Burlington Development Review Board

Development Review Board

ZP-25-92; 24 Grant Street (RM, Ward 3) 24 Grant Street, LLC / Doug Viehmann

To: Development Review Board
From: Mary O'Neil, AICP, Principal Planner
Date: May 6, 2025
RE: 24 Grant Street: ZP-25-92

DRAWING:
Site Plan

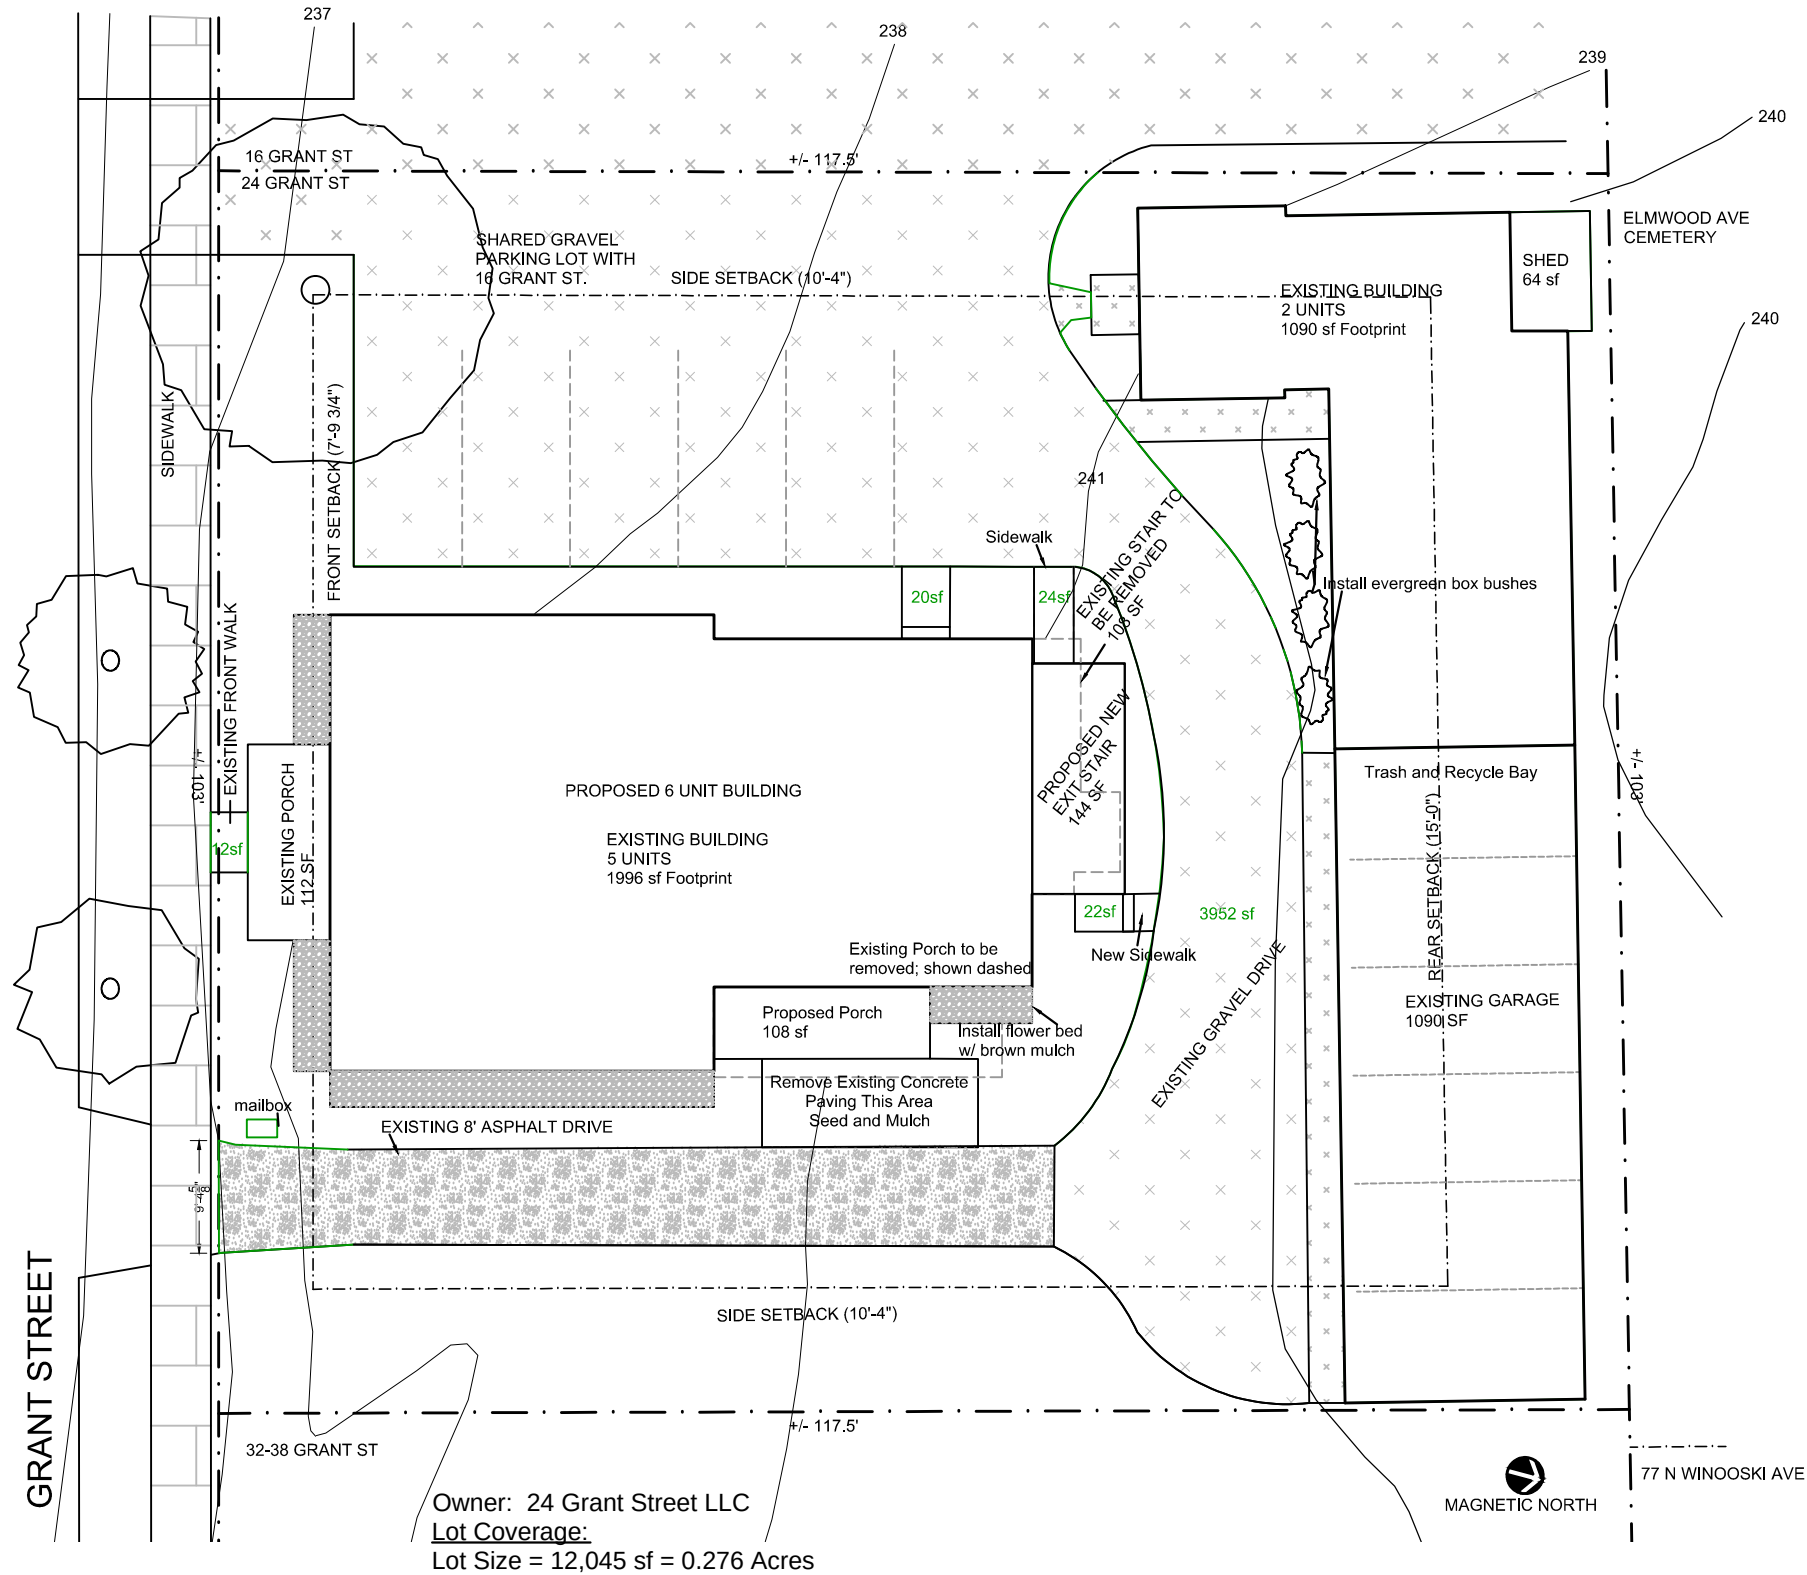
The approved 1983/1983 site plans illustrate two curb cuts, each leading to parking areas/garage. The proposed site plan modifies the 1983 plan by connecting the two vehicular areas. The east driveway is well defined, but the westerly access has created the equivalent of a shared driveway with 16 Grant Street. **Affirmative finding.**

The site plan has functionally changed in that the two access drives (east, west) have been connected in a gravel lane between the buildings; eliminating the 2 parking spaces in front of the garage, and expanding the gravel onto the 16 Grant Street parcel. Parking minimums are no longer applicable and shared access driveways are allowed. **Affirmative finding.**

DATE: 8 MAR 25
REVISED:
SCALE:
1/8" = 1'-0"
DRAWING:
ELEVATIONS
SHEET:
A2.1

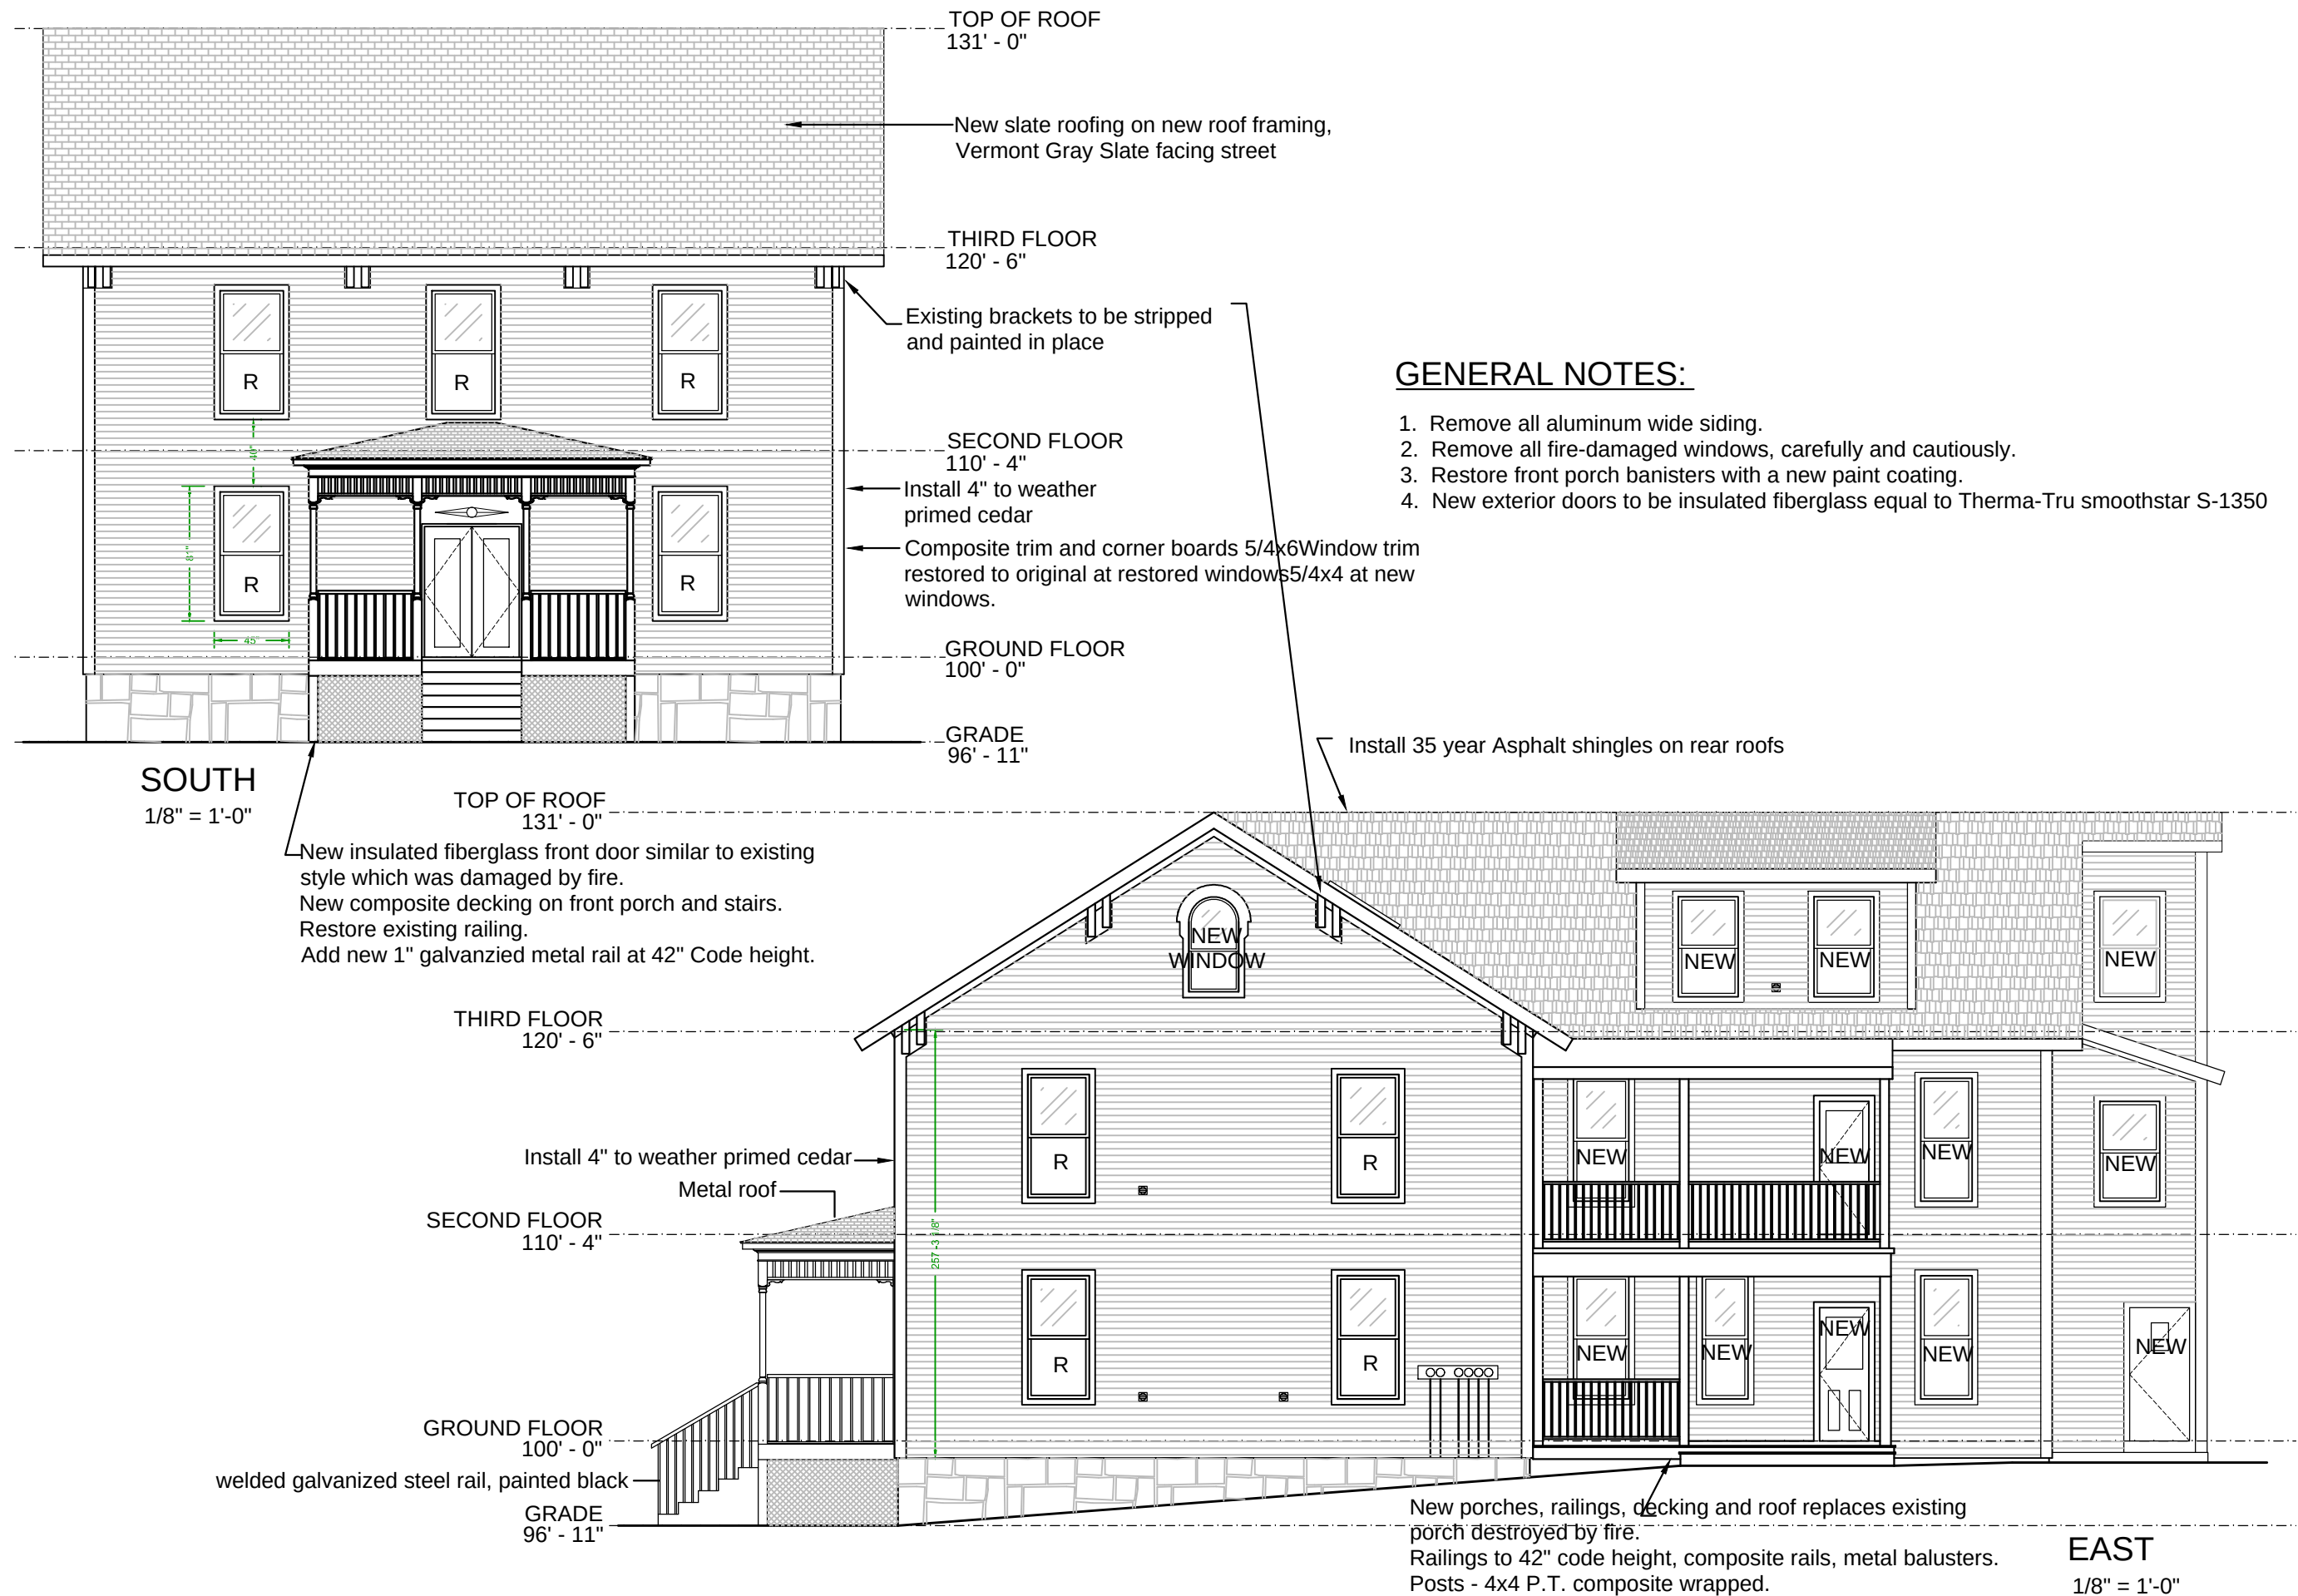
The application proposes re-installation of a Vermont Strata Gray slate roof on the primary structure, while the rear addition will have asphalt shingles. See Plans A 2.1 and A 2.2. **Affirmative finding.**

primed cedar, and the existing brackets are to be stripped and painted in place. Front porch balusters will be repainted, and a Vermont Gray slate roof will be installed on the historic main structure, with asphalt shingles on the rear (north) addition. A new fiberglass door will be installed at the Grant Street entrance. See Plan A2.1. **Affirmative finding.**
